STAFF REPORT
INFORMATION AND ACTION ITEM

SUBJECT: Review of Town Ordinance Compliance for Route 7/690 Interchange

DATE OF MEETING: February 16, 2023

Article 14. Section 2. - Stream and Creek Buffer established, #4, wetlands

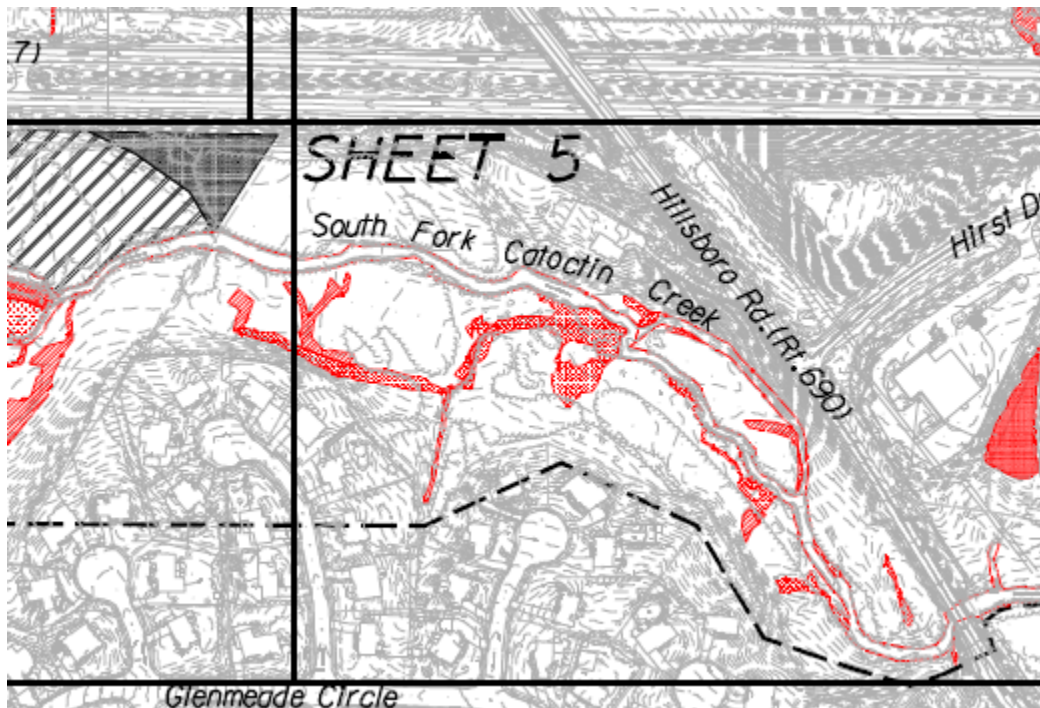
Based on the wetland delineation in the Approved Environmental Assessment, there are wetlands in the proposed construction area. A preliminary jurisdictional determination was provided by the USACE, dated March 27, 2015. We do not have information about the final Jurisdictional Determination, so this is a question that could be asked of the County. Typically, if a wetland is destroyed, the project may choose to create new wetlands or purchase wetlands credits in lieu of creating new wetlands.

Conclusion: Effects on wetlands will be mitigated, through stormwater management, purchase of wetland credits, or other means, prior to the initiation of construction activities.

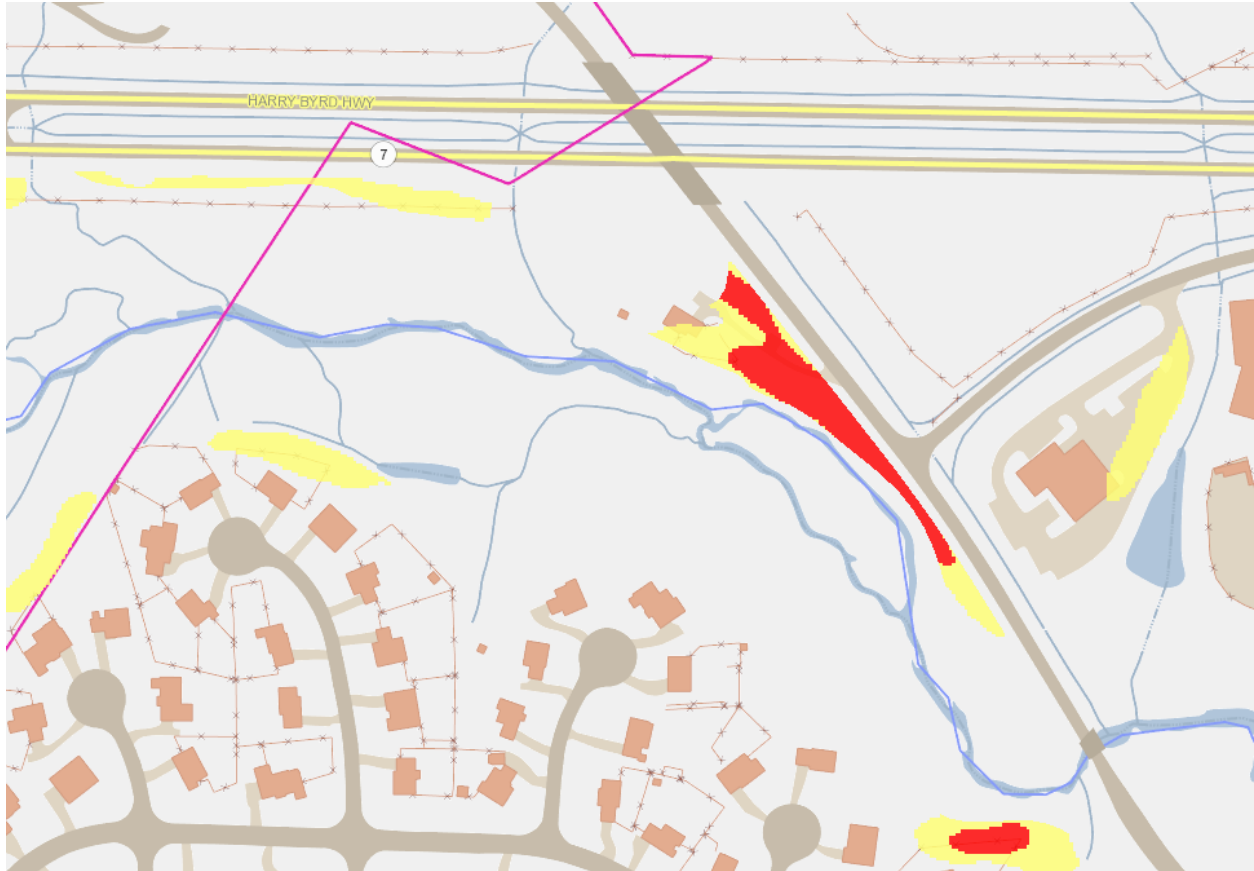
There are locations of steep slopes within the Project area. See the map below:

Conclusion: The 7/690 Project has been reviewed and approved by the Loudoun County Building and Development Department as is required by the Town's Ordinance. It appears that the requirements for steep slope have been met.
